Access Compliance Report

Public Rights-of-Way

(Curb Ramps)

Intersection ID: 43844	Main Street: CURRIER_RD	Cross Street: DELUCA_DR	Location: NW
ADA ID: 0646A96320B1	Ramp Type: BlendTrans1	Initial Pass/Fail: Fail	Overall Compliance: No
		Severity Score: 12.5	
Codes/Mitigation Info/Possible Solution		Field Measurements/Component Compliance

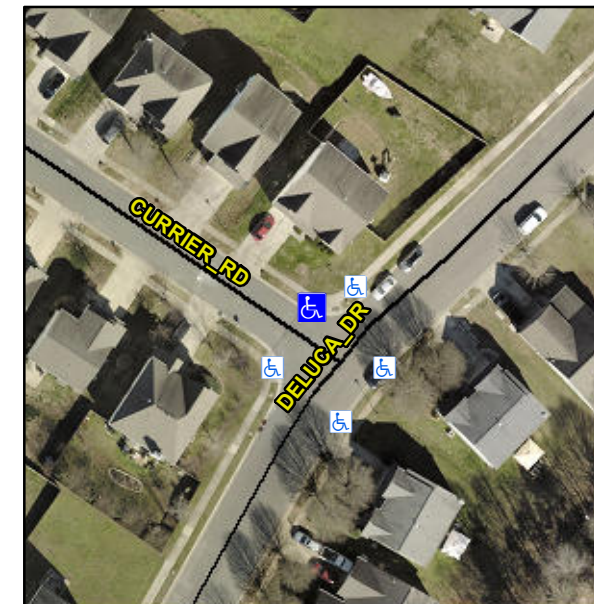
Not Found, R304.5.3

Compliance	Description	Data	Compliance	Description	Data
N/A	Ramp Length (in)	48.0	Yes	BlendTrans Slope (%)	4.8
Yes	Ramp Width (in)	48.0	No	BlendTrans XSlope (%)	6.2
N/A	Flare Type LT	N/A	N/A	Flare Type RT	N/A
N/A	Flare Slope LT (%)	N/A	N/A	Flare Slope RT (%)	N/A
N/A	Flare Traversable LT?	N/A	N/A	Flare Traversable RT?	N/A
N/A	Landing Length (in)	N/A	N/A	DWS Provided?	N/A
N/A	Landing Width (in)	N/A	N/A	DWS Contrast?	N/A
N/A	Landing Slope (%)	N/A	N/A	DWS Length (in)	N/A
N/A	Landing X Slope (%)	N/A	N/A	DWS Full Width?	N/A
N/A	Landing Curb? (Y/N)	N/A	N/A	DWS Offset (in)	N/A
N/A	Shared Landing?	N/A			
N/A	Gutter Ponding?	N/A	N/A	Gutter Slope (%)	N/A
N/A	Gutter Lip Ht (in)	N/A	N/A	Gutter X Slope (%)	N/A
N/A	Painted X Walk1?	No	N/A	Painted X Walk2?	N/A
	X Walk 1 Direction	To SW		X Walk 2 Direction	N/A
	X Walk 1 Width (in)	N/A		X Walk 2 Width (in)	N/A
	X Walk 1 Slope (%)	0.3		X Walk 2 Slope (%)	N/A
	X Walk 1 X Slope (%)	6.5		X Walk 2 X Slope (%)	N/A

N/A	Ramp inside XWalk1?	N/A	N/A	Ramp inside XWalk2?	N/A
	Road Slope (%)	6.5		Clear Space?	N/A
	Road X Slope (%)	0.3	N/A	Clear Space to XWalk (in)	N/A
N/A	Any Obstructions?	N/A	N/A	Storm Grate/Utility Hazard?	N/A
	Obstruction Type			Storm Grate/Utility Type	
		N/A			N/A
			Yes	Surface Condition? (G/P)	Good
			No	Curb Slope (%)	10.8

Remove & Replace Curb Ramp With Two New Directional Ramps or Equivalent.
